Re: City of Unalaska – Storm Drainage Projects - Ilulaa Lake/East Point Road

Waste Management Work Plan Addendum II for Ilulak Lake/East Point Road

**Ilulak Lake / East Point Road & Delta Way
Drainage Improvements
DPW Project No. 10101
Dutch Harbor, Alaska**

Alaska Department of Environmental Conservation
Comments on the Draft “Waste Management Work Plan Addendum for Ilulaq Lake/East Point Road”
Commenter: Holly Weiss-Racine (ADEC) Comments Developed: January 31, 2017

TITLE: PTARMIGAN FLATS
STORM DRAIN PLAN & PROFILE

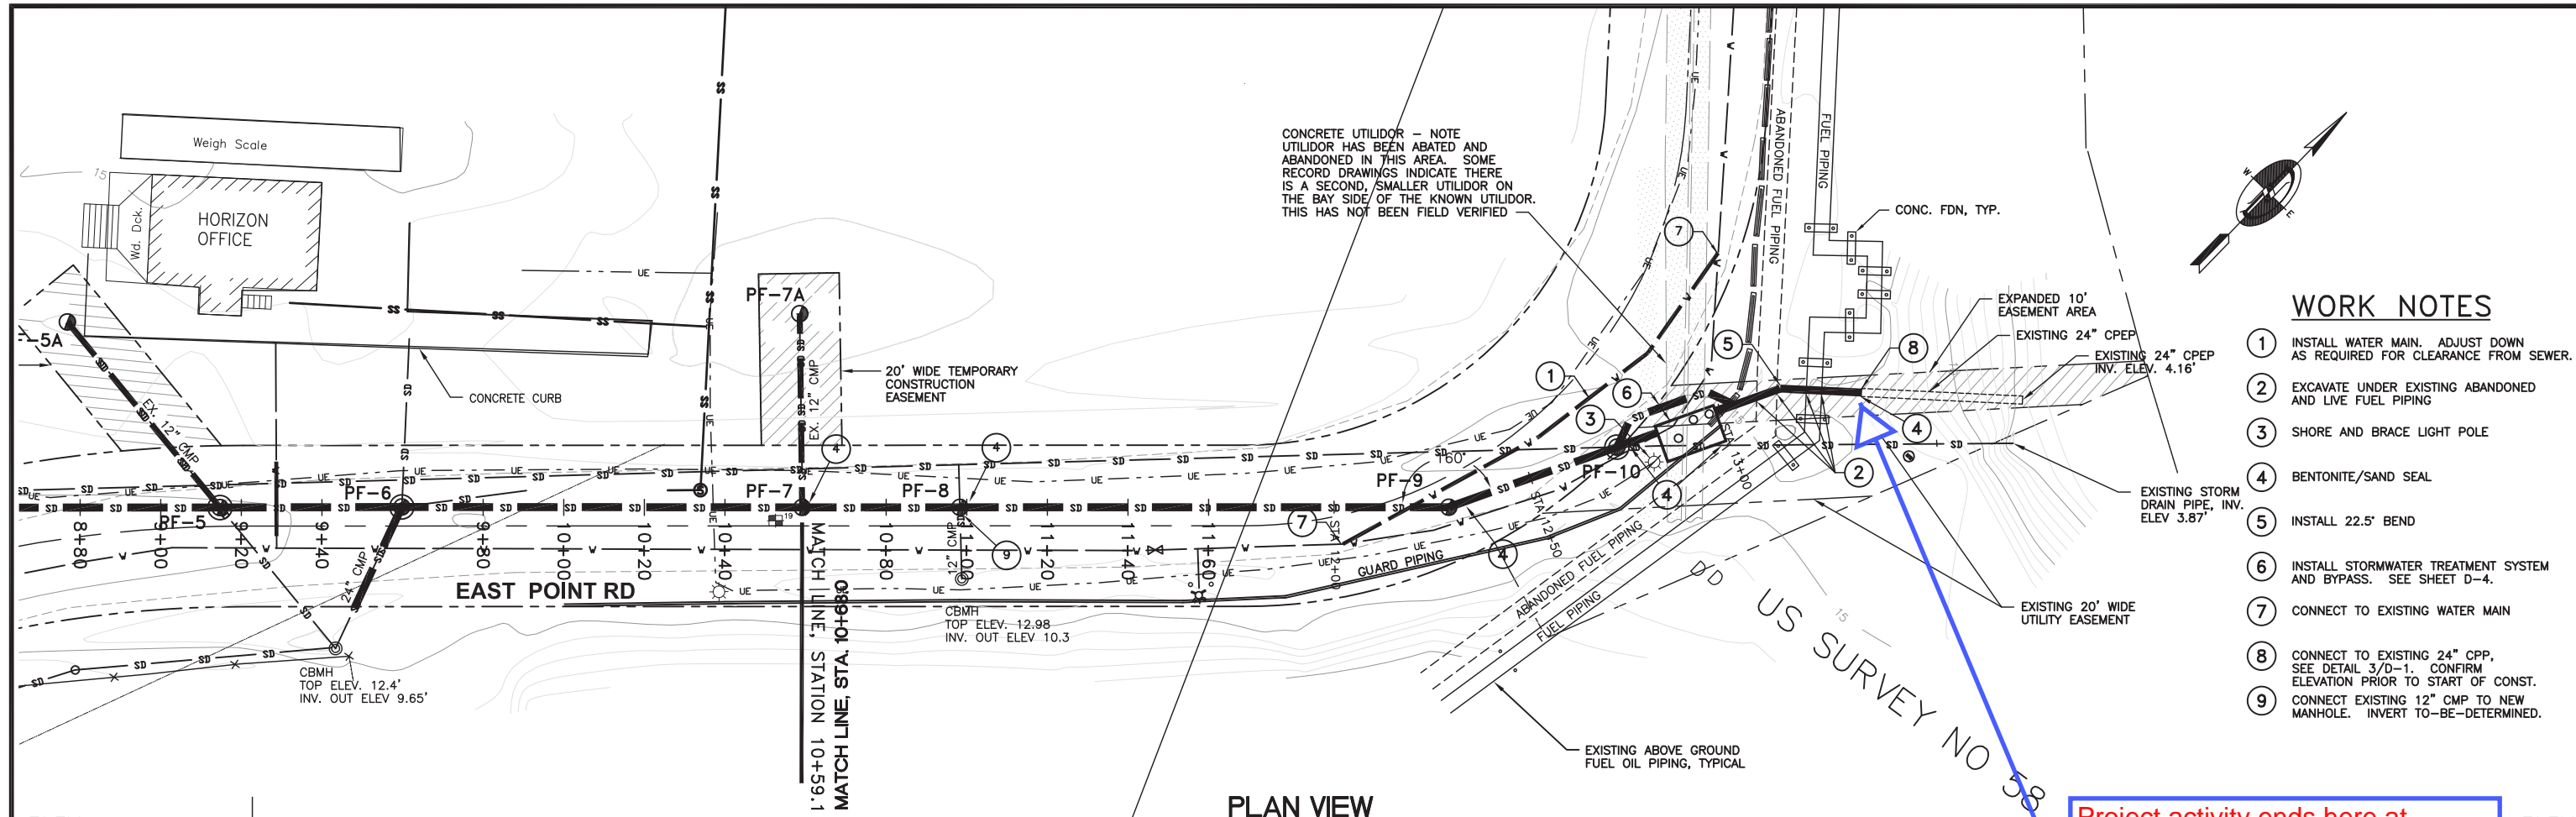
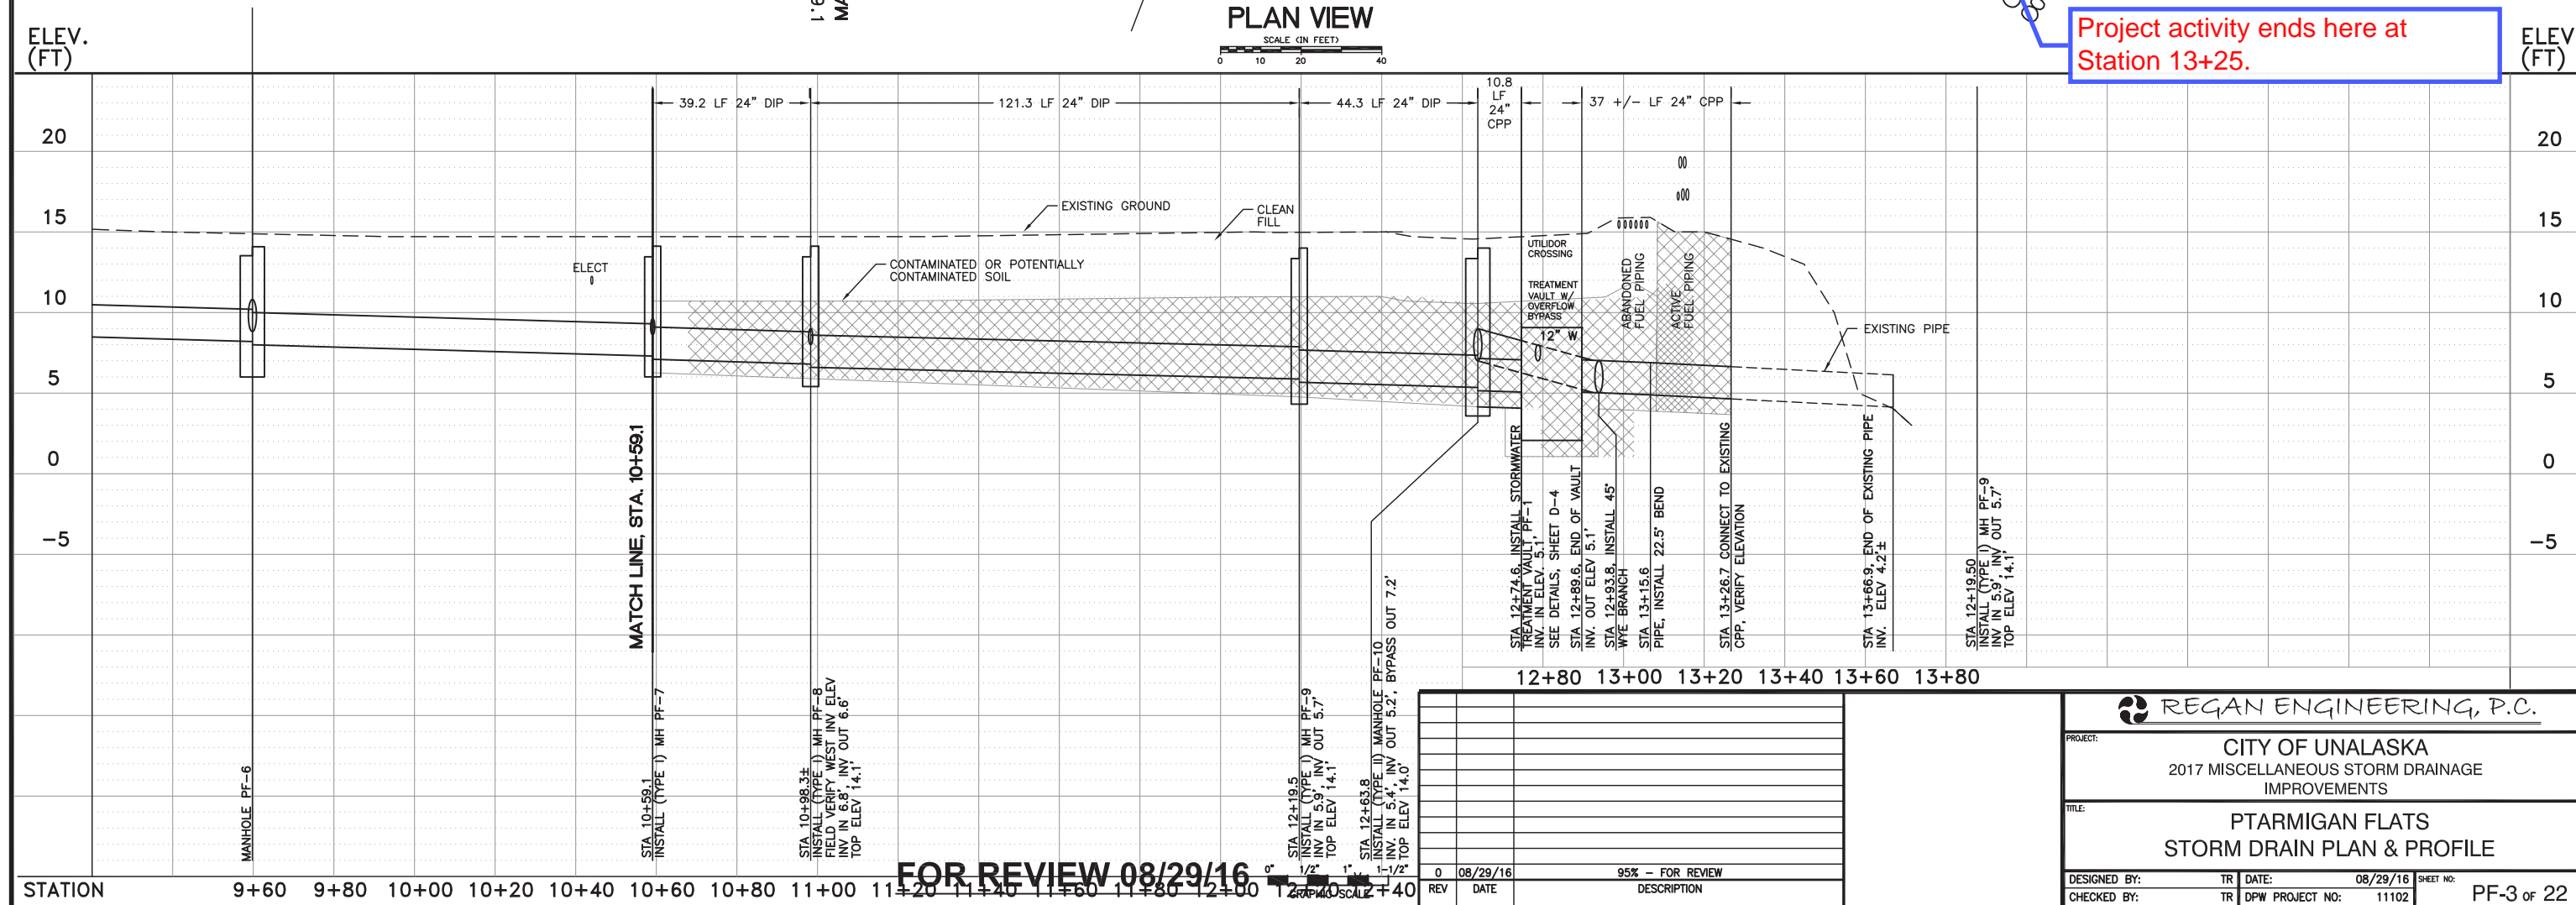
Cmt. No.	Pg. & Line	Sec.	Comment/Recommendation	Response
1.	1.1	1.0	Please add the referenced figure to Attachment A of this work plan (with stationing that makes it clear where the project activity is taking place).	Four sheets have been added to Attachment A from the civil plans. The relevant work occurs from previously characterized Station 7+40 to Station 13+25. As before work above 7+40 (Above East Point Road in the Matson Yard) was considered outside the scope because groundwater is not anticipated and responsible party maps define the area as outside the contaminated site.
